TSB150105
-----------

## Technical Service Bulletin

New Aftertreatment Selective Catalyst Reduction (SCR) Catalyst Part Numbers

Figure 3, Right-hand Vertical SCR (left) / Right-hand Horizontal SCR (right)

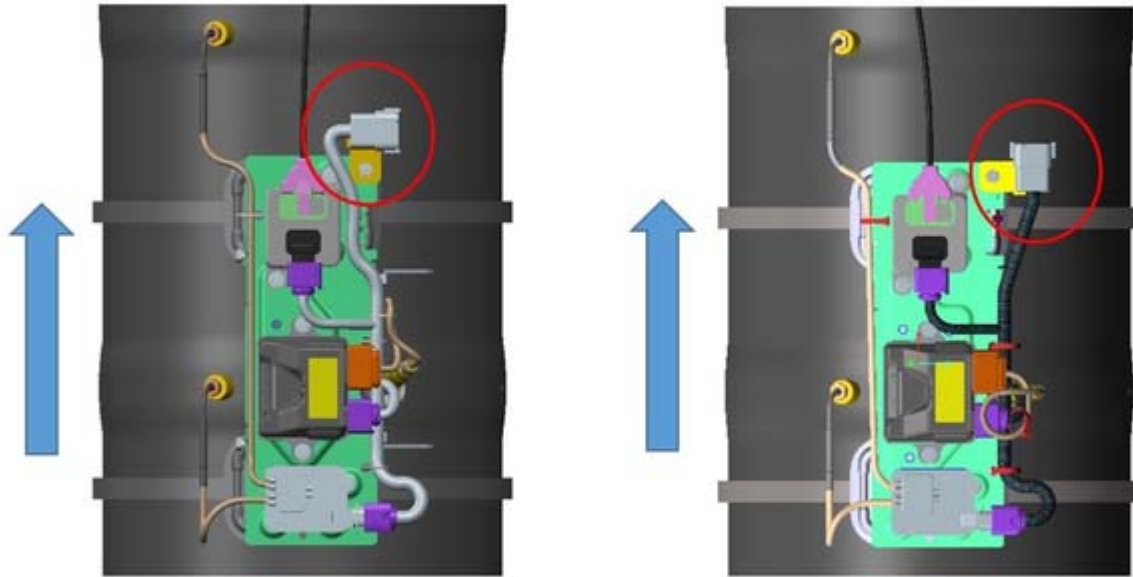
Figures 3 and 4 provide images to differentiate between the different SCR configurations when determining what engine harness to use. The horizontal and vertical nomenclature describes the orientation of how the SCR is installed in the equipment. The OEM wiring harness connectors are circled in the images; direction of exhaust flow is shown by the arrows.
